Subject: Callaway Plant, Unit 1 - Amendment No.14 to Facility

Operating License NPF-30

SUPPORTING AMENDMENT NO. 14 TO OPERATING LICENSE NO. NPF-30

CALLAWAY PLANT, UNIT 1

FIGURE 6.2-1
OFFSITE ORGANIZATION

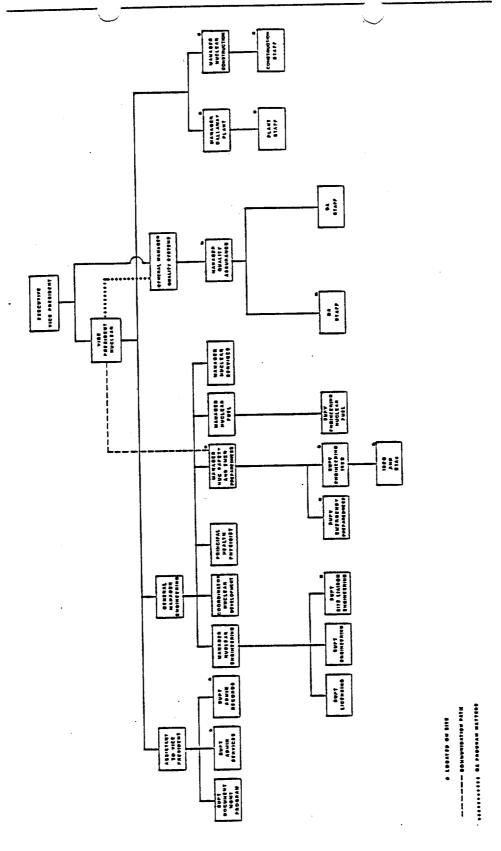
By letter dated November 18, 1985, Union Electric Company (the licensee) requested several changes to the Technical Specifications for the Callaway Plant, Unit 1. The requested changes involve the utility's quality assurance organization and would change Figures 6.2-1 and 6.2-2 and Section 6.5.1.2 of the plant Technical Specifications.

The licensee desires to establish a new corporate level position of General Manager, Quality Systems, to whom the on-site Manager, Quality Assurance will report. Previously, the Manager, QA was located offsite and reported to the Vice President, Nuclear. In accordance with the proposed change, the new General Manager, Quality Systems will have access to the Vice President, Nuclear on QA Program matters, but both of these individuals will now report to the Executive Vice President. The proposed change will enhance the independence of the QA organization from the plant operations organization.

The revised QA organization will meet the criteria set forth in the Standard Review Plan, Section 17.2, and in our opinion represents an improvement over the existing QA organization. It is, therefore, acceptable.

FIGURE 6.2-2
UNIT ORGANIZATION

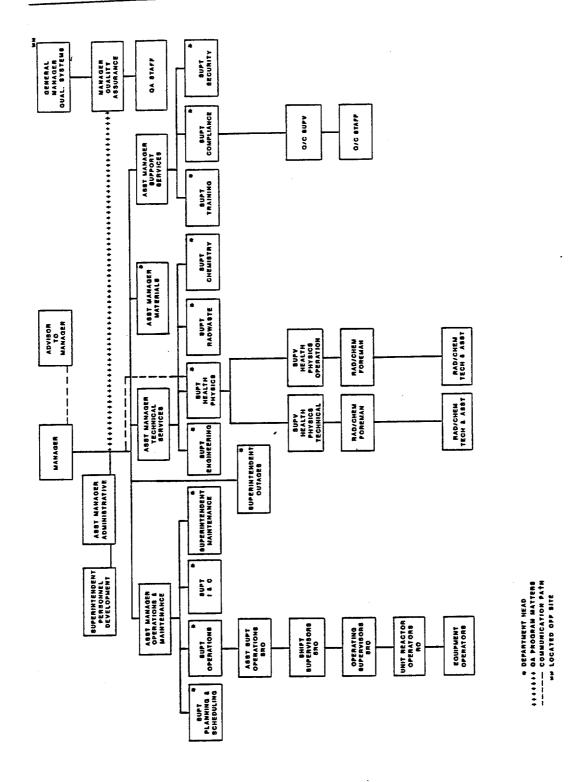
At the plant level, the Manager, QA will replace the Assistant Manager, QA who previously was the senior QA manager on-site. The Assistant Manager, QA will be replaced at the site by two site Superintendent positions, thereby increasing the QA management resources on-site. The Manager, QA will have direct access to the Manager, Callaway Plant on all QA Program matters.
